Mercury Racing X-Haust Assemblies

Situation

- a - Lower exhaust pipe
- b - Steering actuator

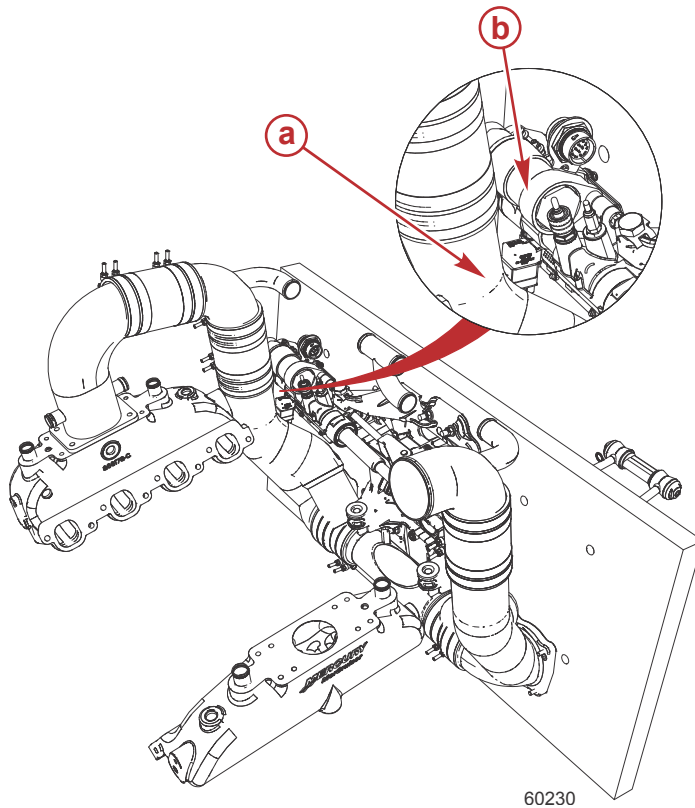
Axisus/Joystick model boats with a transom that is more than 2 in. thick, and are using the X-Haust kit, may have the lower exhaust pipe contacting the steering actuator. This situation could affect the steering ability of the watercraft. All watercraft using the X-Haust assembly should be inspected and repaired if contact is observed.

Turn the drive full port and full starboard while observing the clearance between the steering actuator and the lower exhaust tube on the starboard side of the engine. Replace the lower exhaust tube on the starboard side of the engine if contact is made (only the lower pipe on the starboard side of the engine will be required).
